Errata for USB 2.0 ECN: Link Power Management (LPM) – 7/2007

Host Initiated Resume latency changes

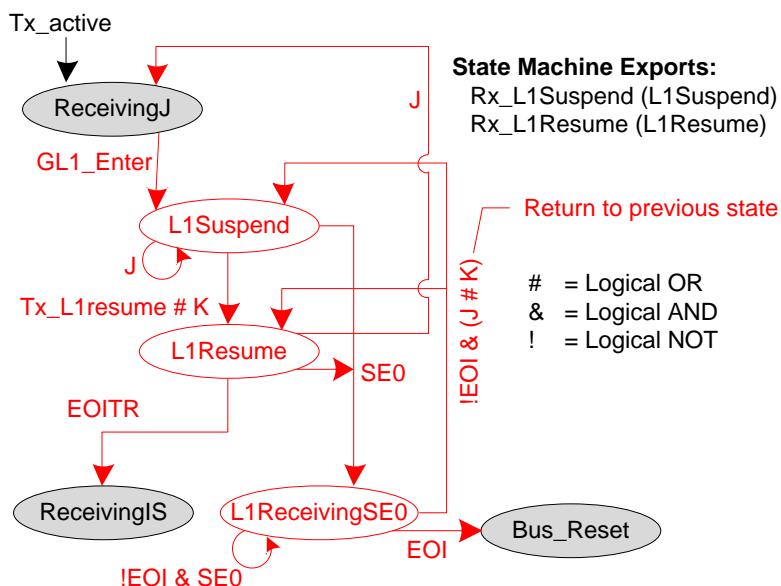
Port States			Description
Hub DS Port (Remote Wake)	Hub US Port	Adj. DS Port	
	L2	L0	USB2 defined resume. Hub reflects resume signaling upstream (transitions upstream port out of L2) and down all enabled (L0) ports.
		L1	Resume signaling is only transmitted through (downstream) ports that are in L0.
		L2
